# Dubbo Zirconia Project

# Response to Submissions

State Significant Development  
Application SSD\_5251

**December 2013**

Figure 1  
REVISED MACQUARIE RIVER WATER  
PIPELINE AND PUMP STATION

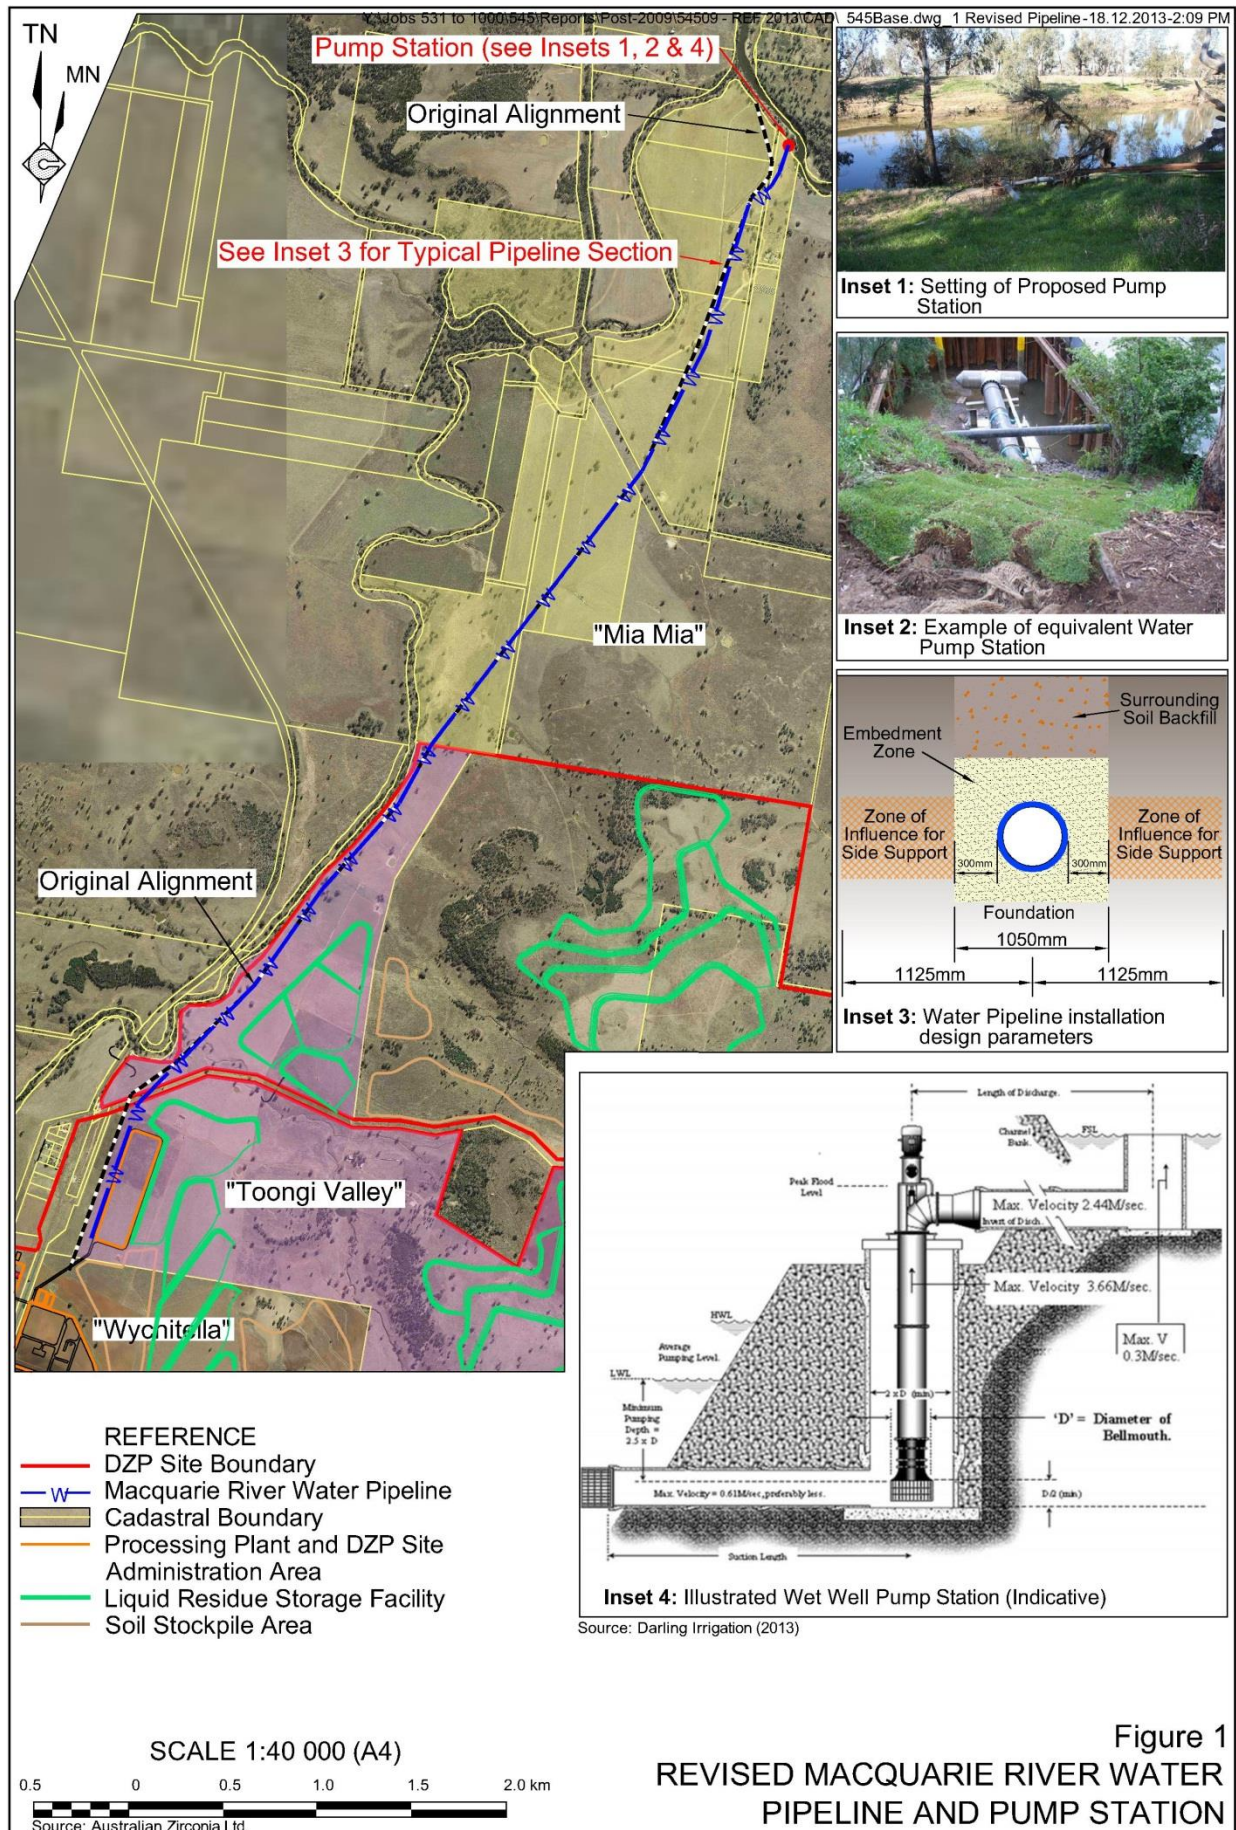
Following further discussion with the land owner of the “Mia Mia” property which fronts the Macquarie River, the proposed location of the pump site has been moved slightly south. A small deviation in the alignment of the pipeline has subsequently been proposed. **Figure 1** presents the proposed minor adjustment as a modified version of EIS **Figure 2.3**.

The field survey and additional investigations completed by OzArk confirm that the revised location of the pump site would not require any additional disturbance to that assessed in the EIS. OzArk also confirm that no areas within the Macquarie River Water Pipeline represent native vegetation community types or derived native grasslands. The pipeline is 100% located in cleared agricultural ploughed land dominated by an understory greater than 50% weeds (see **Appendix 1a**).

No additional Aboriginal Sites or Potential Archaeological Deposits (PADs) were identified within the modified pipeline corridor of pump site (see **Appendix 1b**). It is noted that one additional artefact was identified adjacent to the previously recorded extent of Site MM-AS-01 and the extent of this site has therefore been extended. Notably, the proposed realignment of the pipeline avoids both the new artefact and Site MM-AS-01.

As no new sites were identified within the modified pipeline route alignment, this minor modification to the Macquarie River Water Pipeline alignment would not impact on Aboriginal heritage values.
